Amendment 3

Solicitation Number 25-01

Temporary School Facilities for Colegio Ponceño

A-102

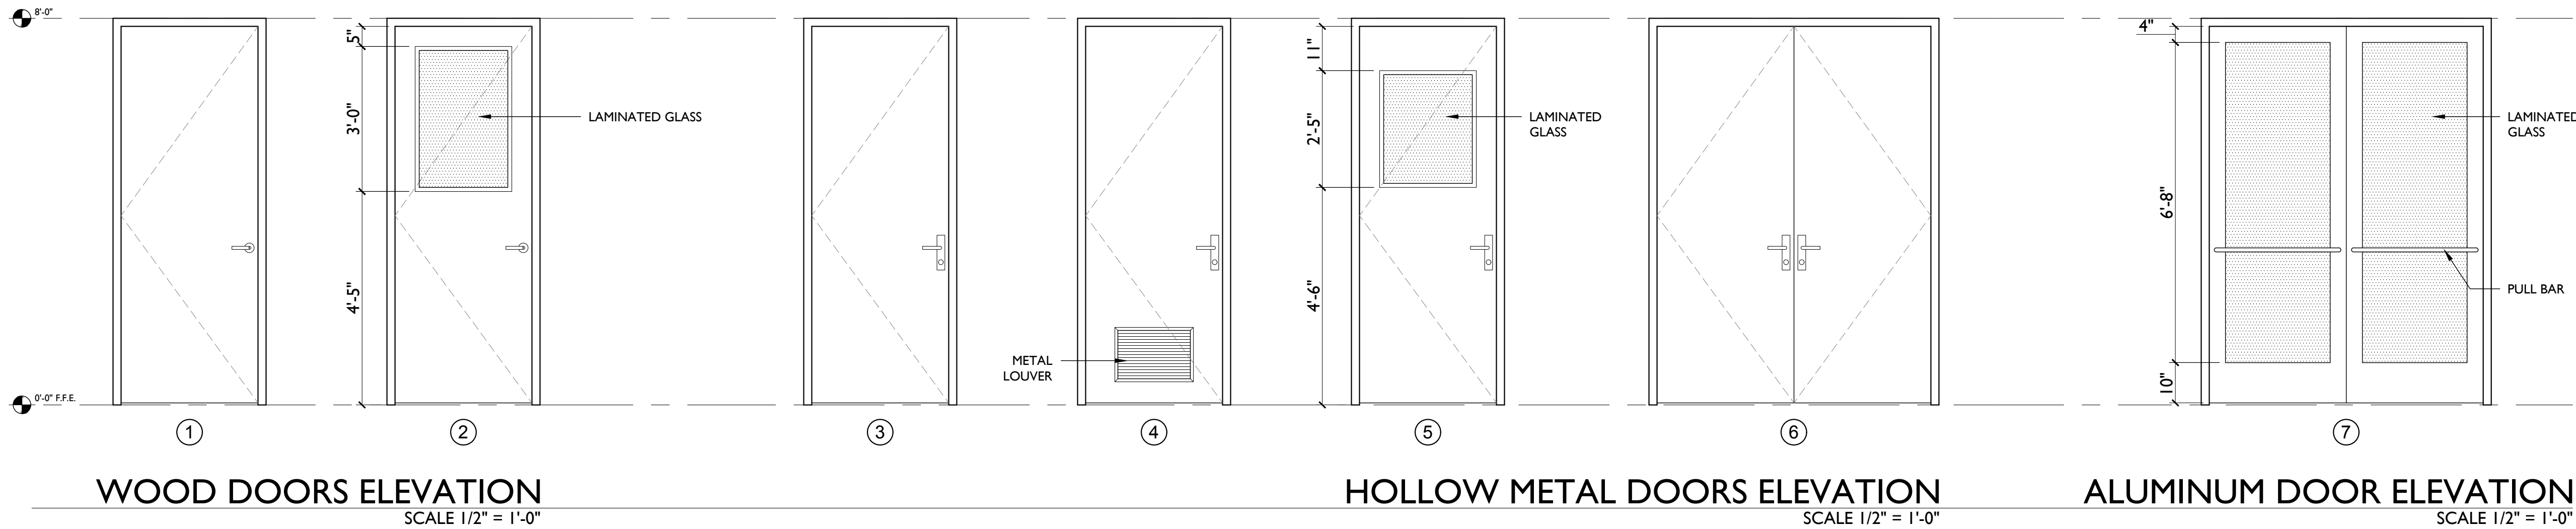
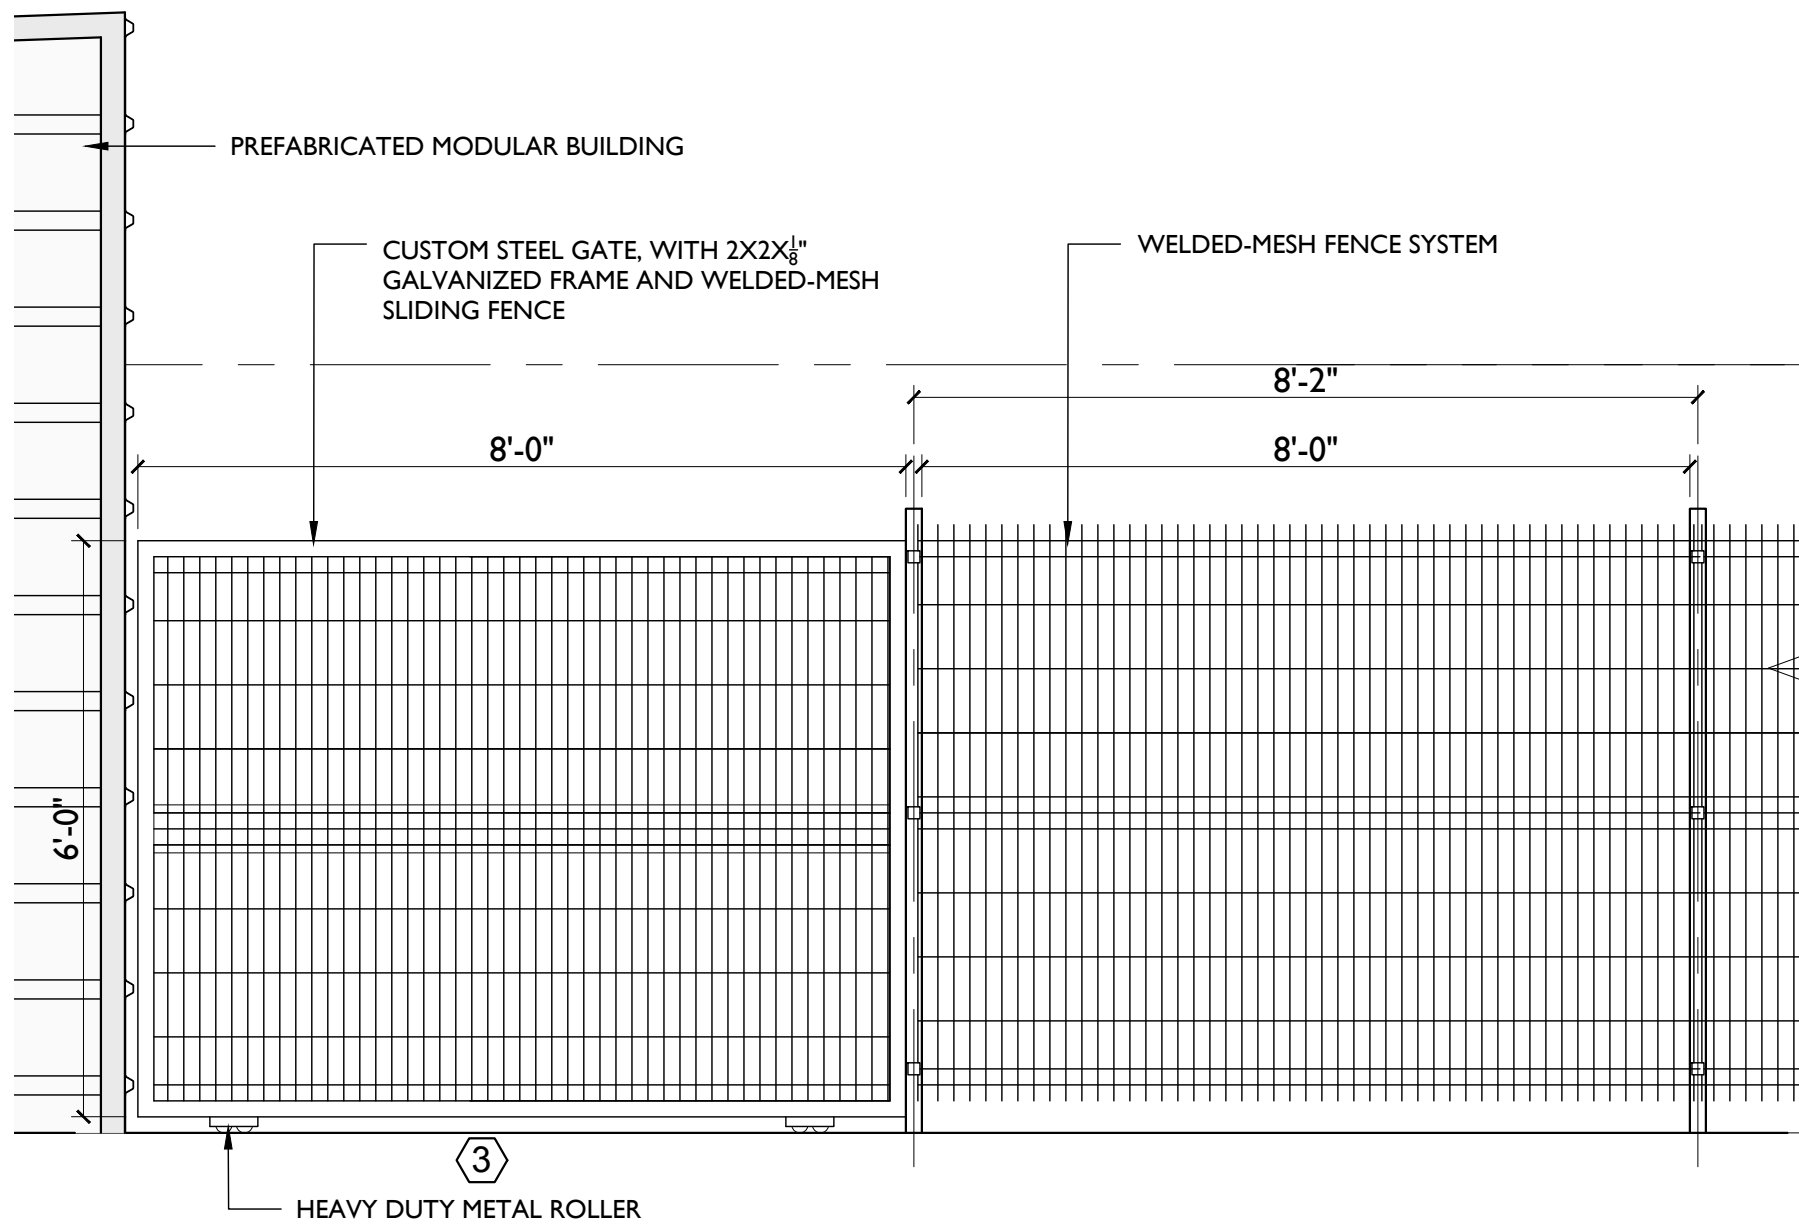
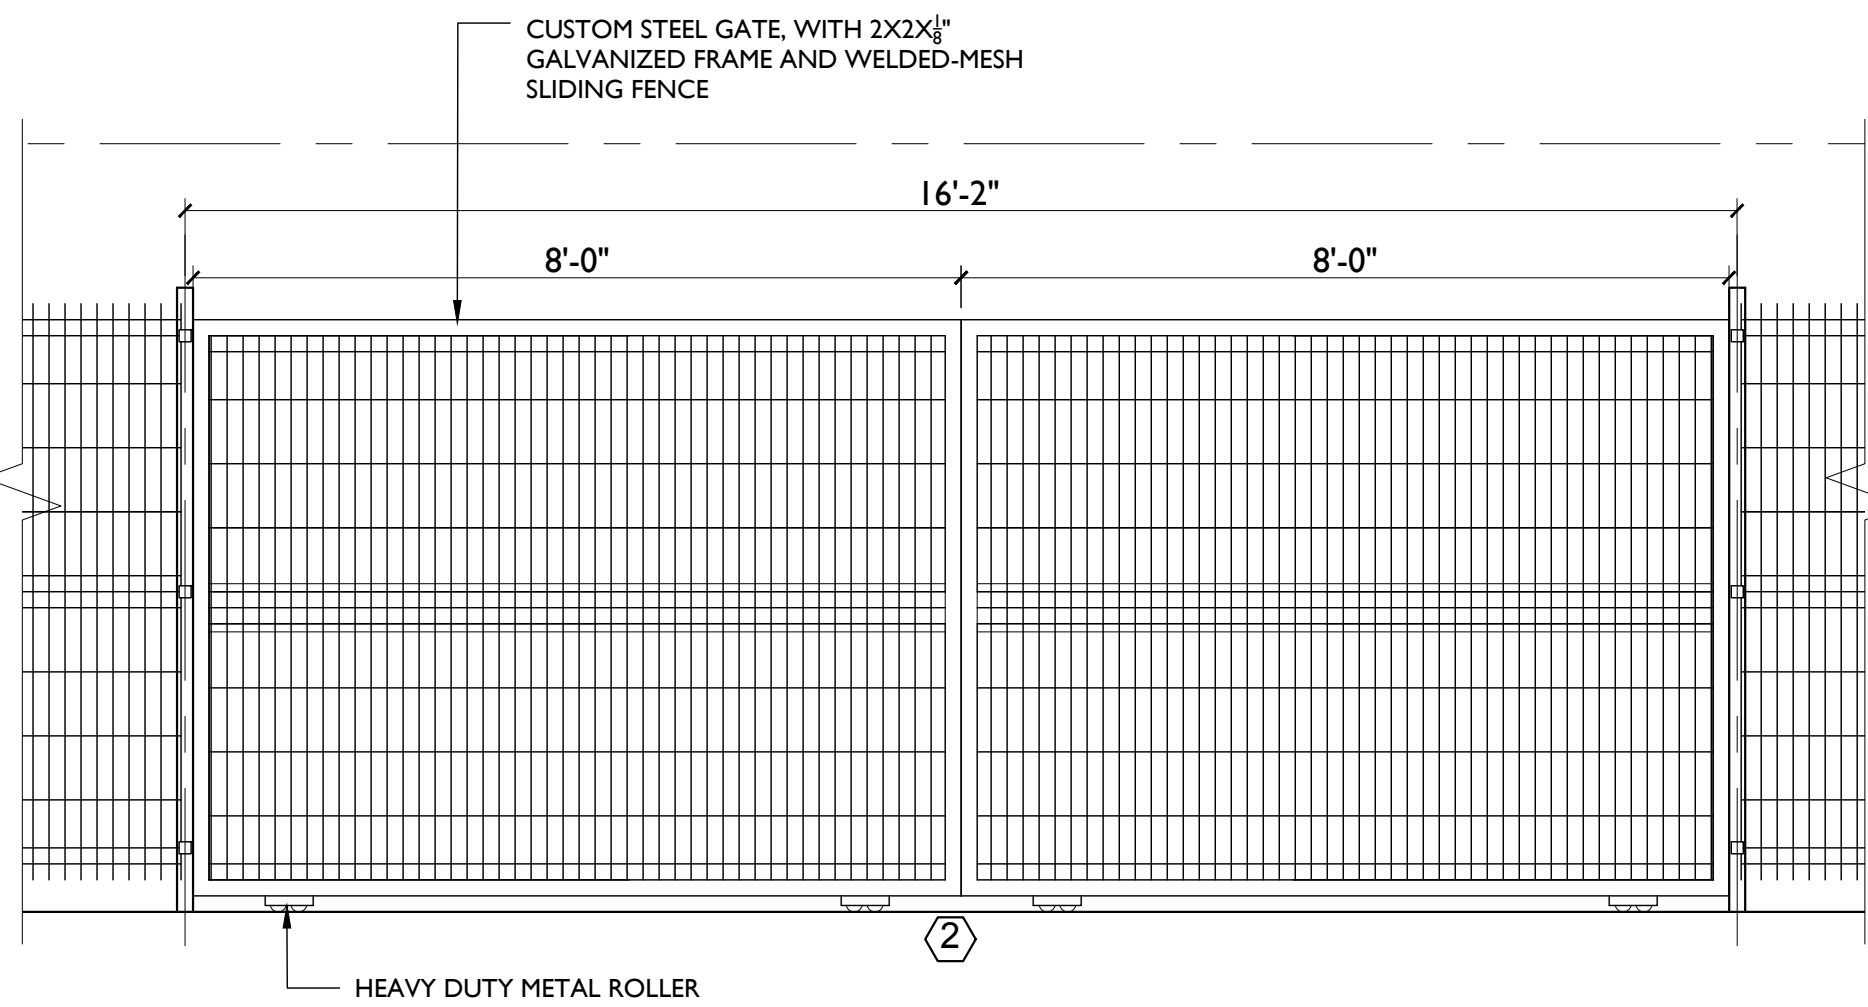
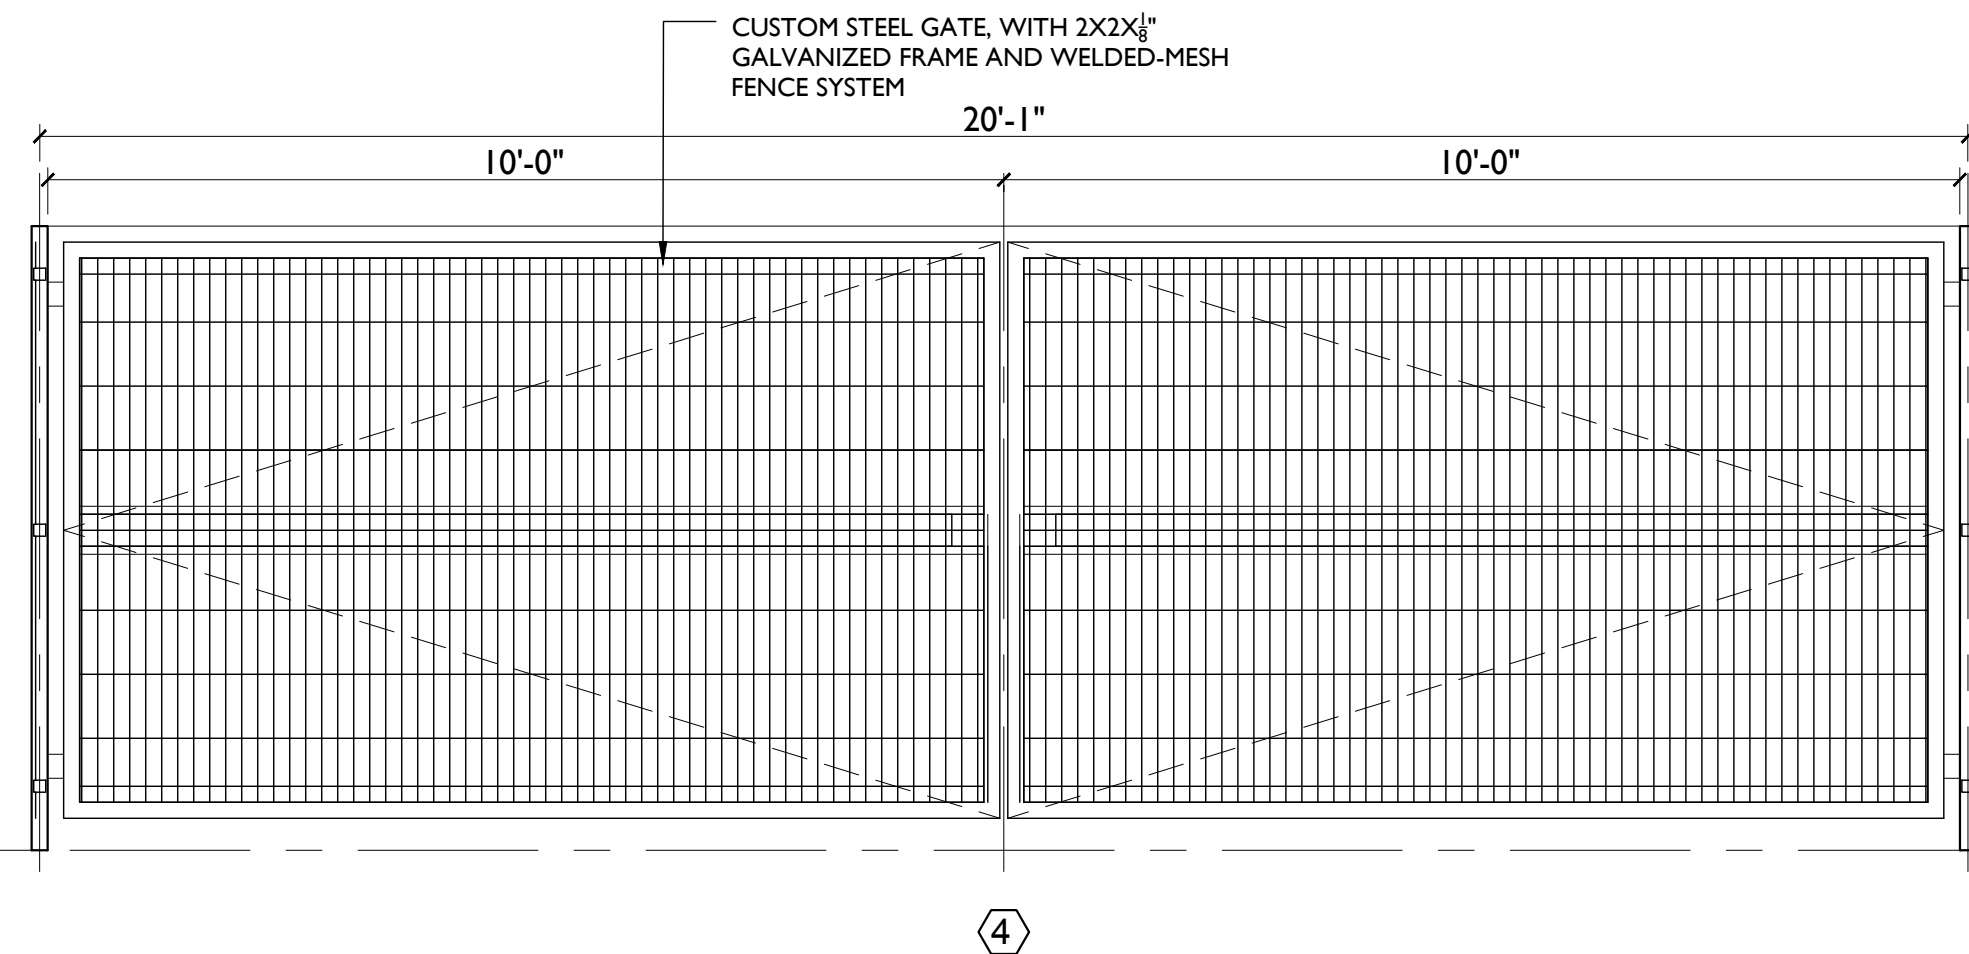
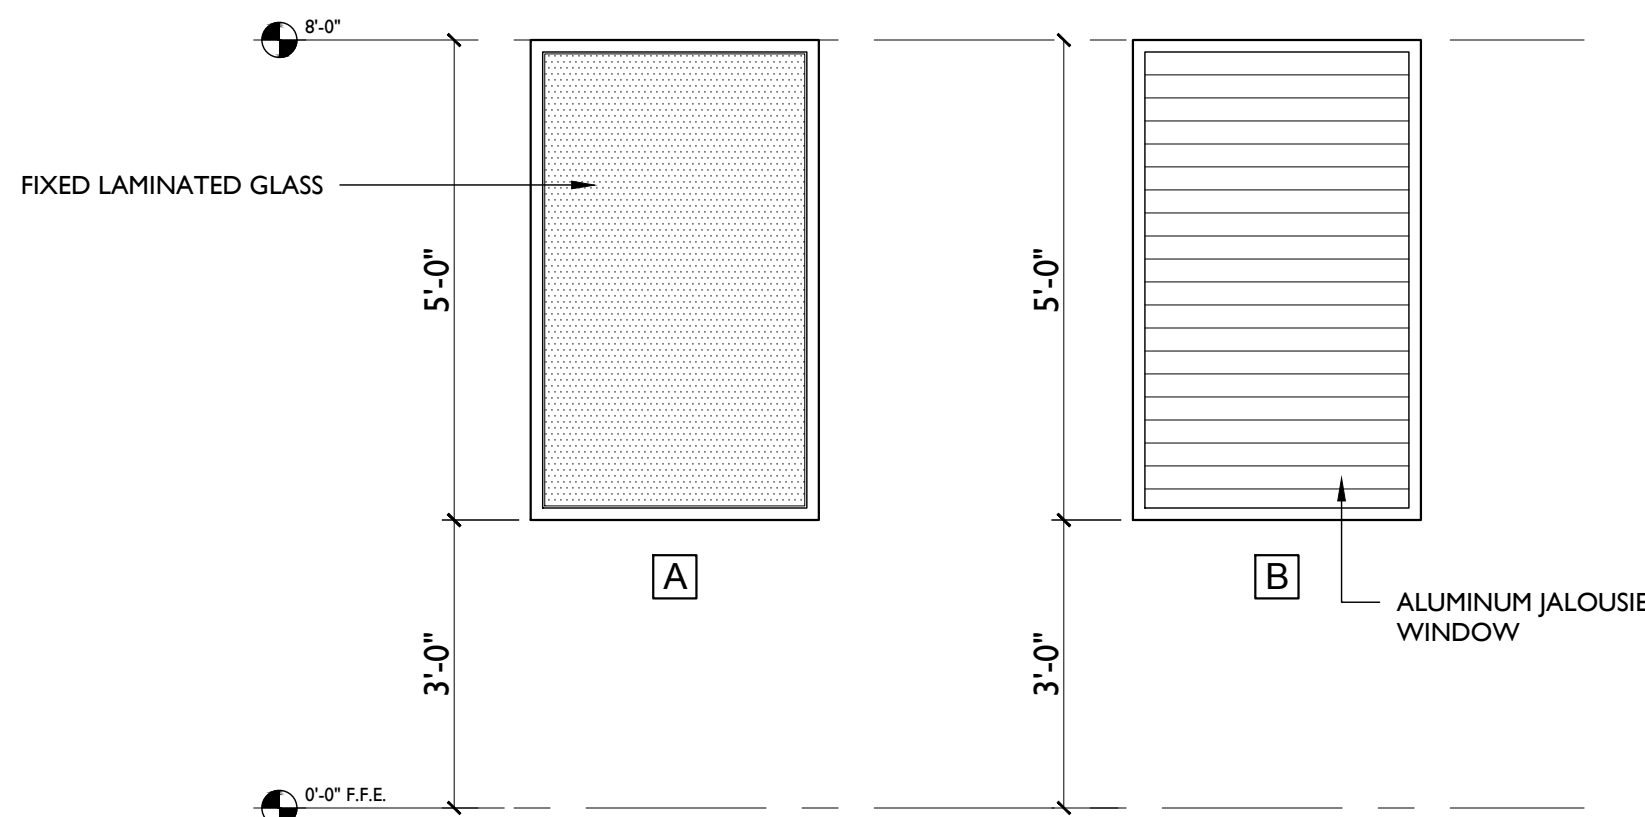
12. Question 19L: We previously requested the scope of work in the Pavilion to accommodate the Physical Education facilities (offices, classroom, gym, and restrooms). Although Addendum No. 2 states "Please refer to the attached drawing," these drawings were not uploaded to the website. We need elevations and sections to help clarify the work. Sheet AS-101 shows it best, but a lot of information is missing to fully understand it. Is this a new construction over part of the existing court? Is it a basement to be modified beneath the existing court? If it is a modification area, does it include any demolition by the Proposer, or as indicated in Question 19Q, is there no demolition involved? There is also a lack of clarity regarding finishes, doors, etc.

Answer: That level is an existing condition on the Pavilion basement; selective demolition is required, and new construction for one classroom, 2 offices, and storage. See attached drawings.
